Access Compliance Report

Public Rights-of-Way

(Curb Ramps)

Intersection ID: 10041826	Main Street: WILLOW_ROCK_DR	Cross Street: N/A	Location: NW
ADA ID: C27040CC9A01	Ramp Type: Perp	Initial Pass/Fail: Fail	Overall Compliance: No
Severity Score: 26.25			
Codes/Mitigation Info/Possible Solution		Field Measurements/Component Compliance

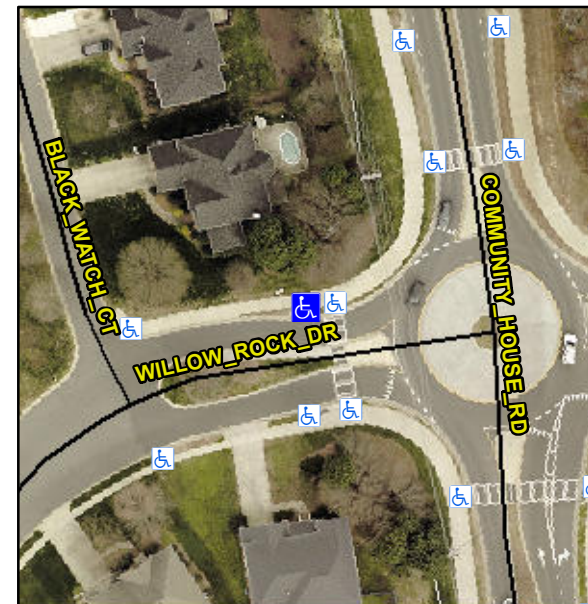
R304.2.2, R304.5.3

Compliance	Description	Data	Compliance	Description	Data
N/A	Ramp Length (in)	51.0	No	Ramp Slope (%)	14.9
Yes	Ramp Width (in)	116.0	No	Ramp XSlope (%)	3.8
N/A	Flare Type LT	N/A	N/A	Flare Type RT	N/A
N/A	Flare Slope LT (%)	N/A	N/A	Flare Slope RT (%)	N/A
N/A	Flare Traversable LT?	N/A	N/A	Flare Traversable RT?	N/A
N/A	Landing Length (in)	N/A	N/A	DWS Provided?	N/A
N/A	Landing Width (in)	N/A	N/A	DWS Contrast?	N/A
N/A	Landing Slope (%)	N/A	N/A	DWS Length (in)	N/A
N/A	Landing X Slope (%)	N/A	N/A	DWS Full Width?	N/A
N/A	Landing Curb? (Y/N)	N/A	N/A	DWS Offset (in)	N/A
N/A	Shared Landing?	N/A			
N/A	Gutter Ponding?	N/A	N/A	Gutter Slope (%)	N/A
N/A	Gutter Lip Ht (in)	N/A	N/A	Gutter X Slope (%)	N/A
N/A	Painted X Walk1?	No	N/A	Painted X Walk2?	N/A
	X Walk 1 Direction	To S		X Walk 2 Direction	N/A
N/A	X Walk 1 Width (in)	N/A	N/A	X Walk 2 Width (in)	N/A
	X Walk 1 Slope (%)	2.1		X Walk 2 Slope (%)	N/A
	X Walk 1 X Slope (%)	3.5		X Walk 2 X Slope (%)	N/A

Remove & Replace Entire Ramp.
